**DOCUMENT 00 90 00**  
**ADDENDUM**

**ADDENDUM NO. [1]                      Date: March 7, 2019**

**RE:                      TOWN OF HAMBURG OFFICE AND GARAGE**  
**S1631A COUNTY HWY K**  
**CHASEBURG, WI 54621**  
**HSR PROJECT NO. 17087**

1 OVERALL SITE PLAN  
1" = 40'-0"

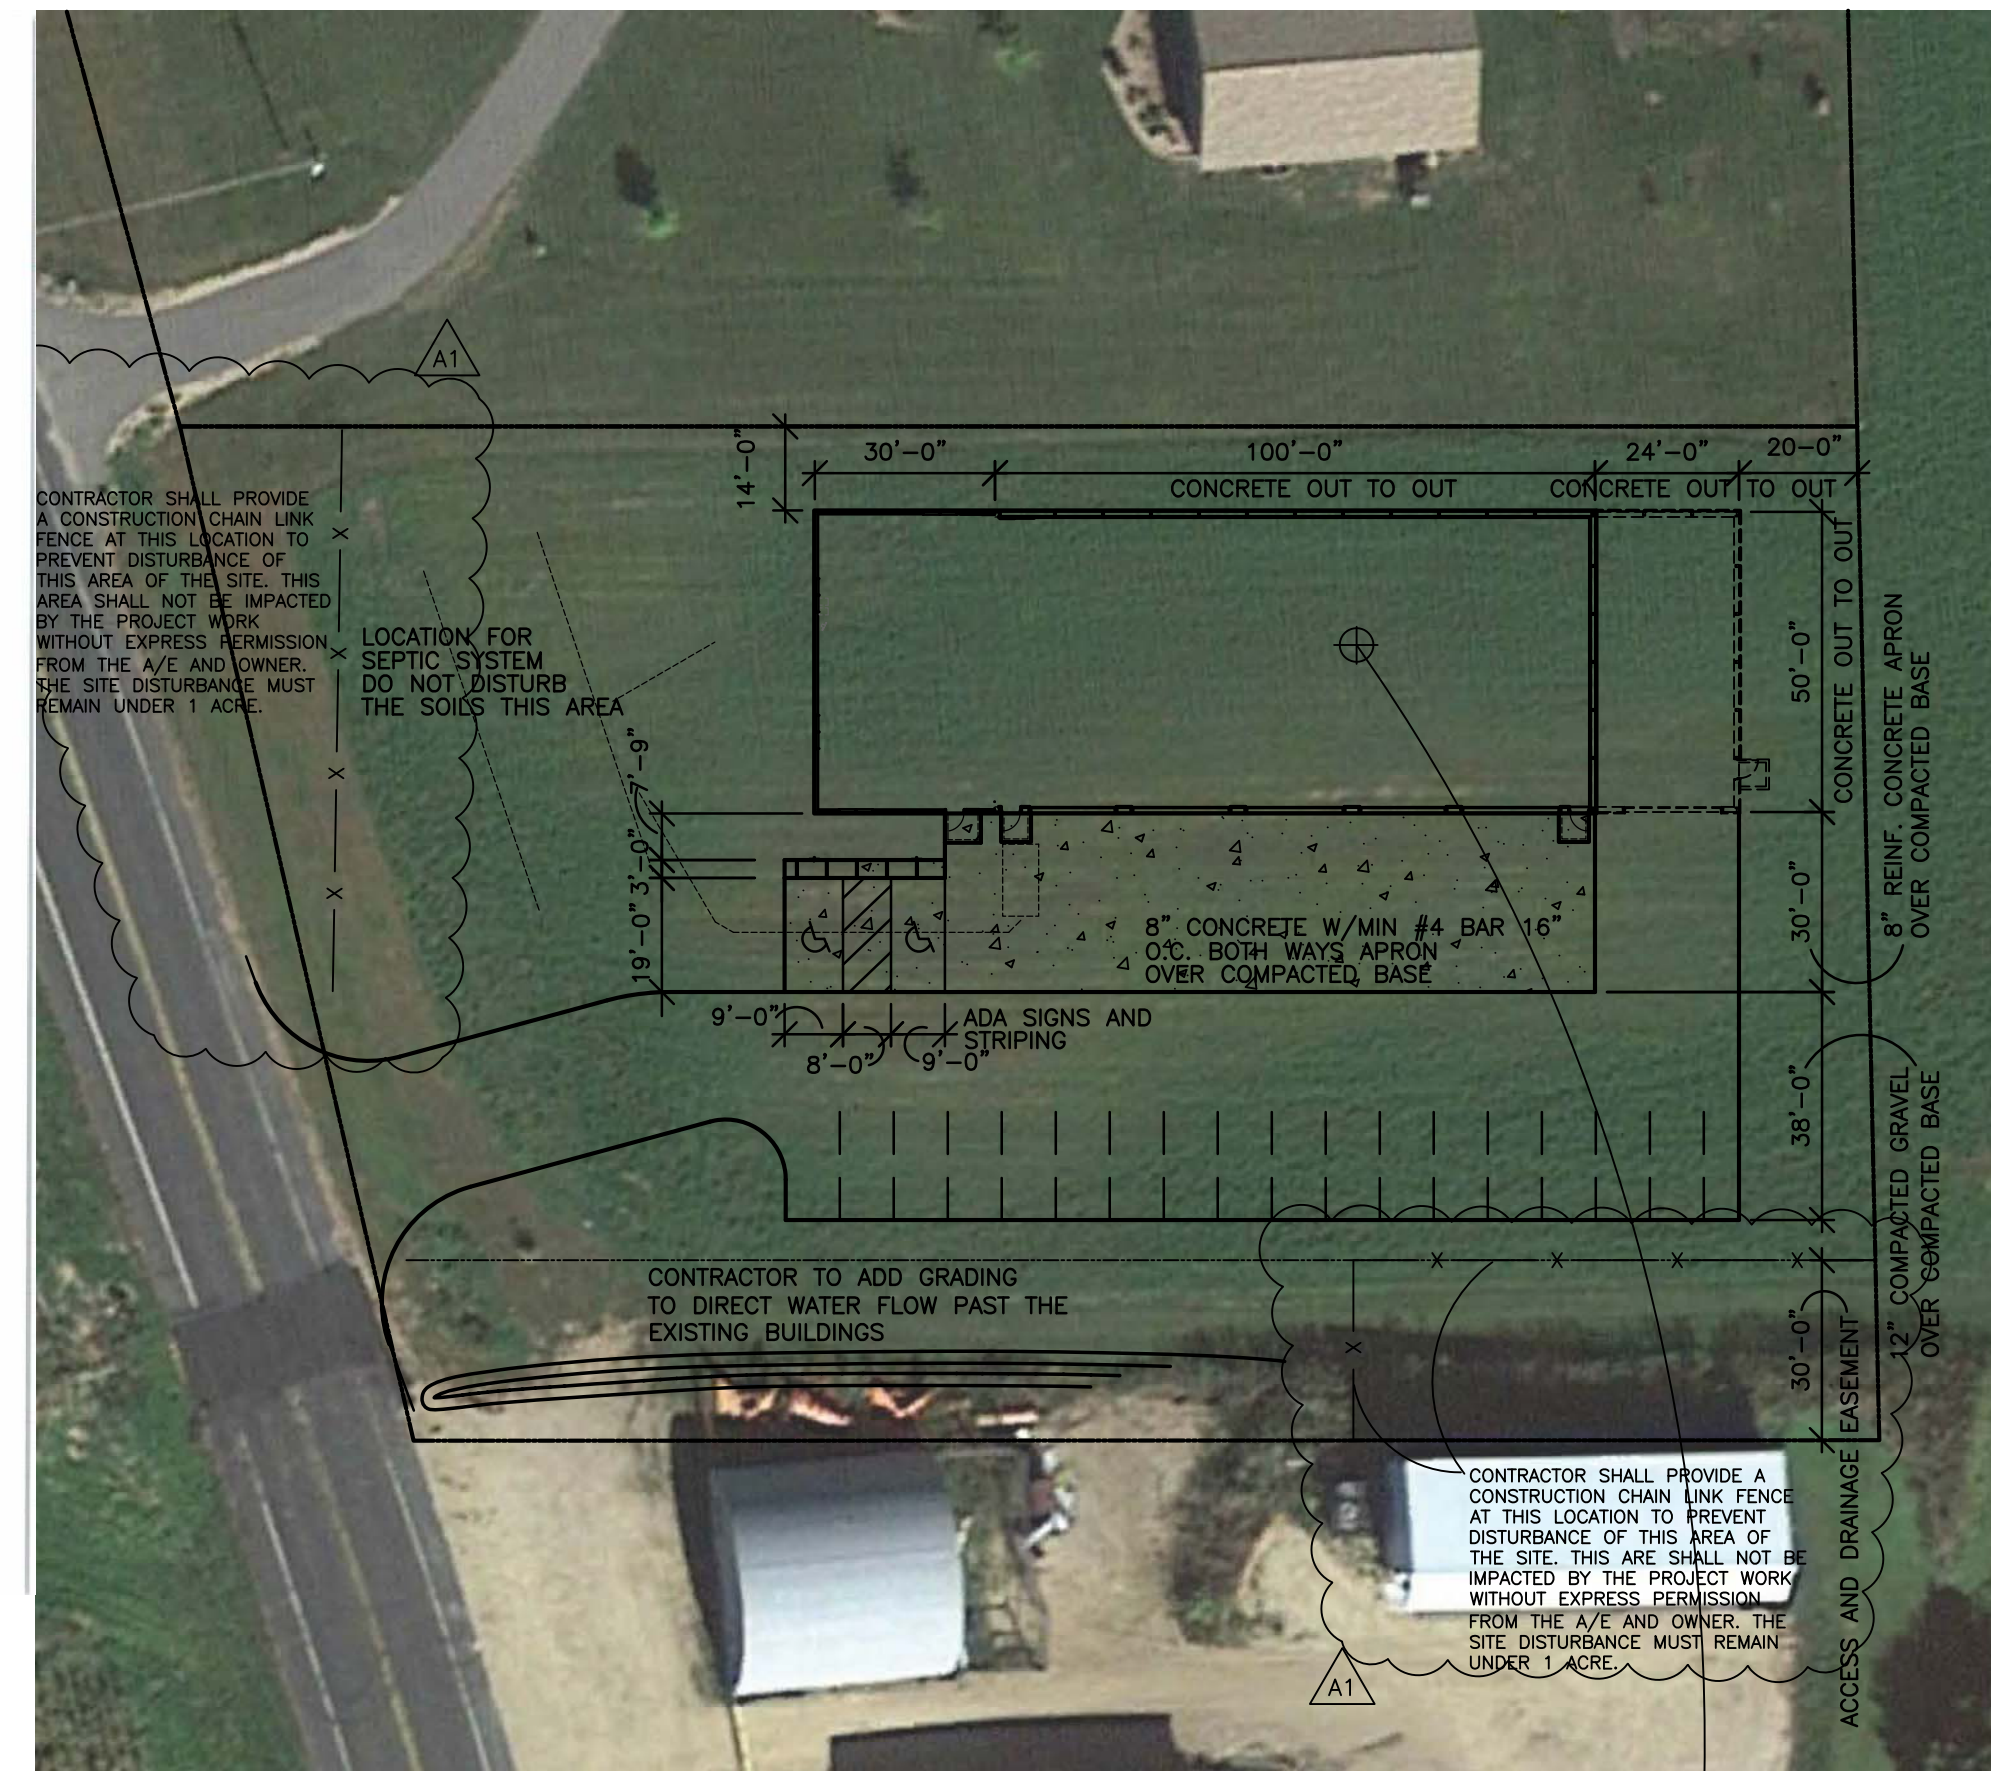
- c. This is a "desired" schedule. The bidders are asked to provide a schedule on the bid form that is realistic for them.
  - d. 1A001: See notes on added chain link site fence and site maintenance.
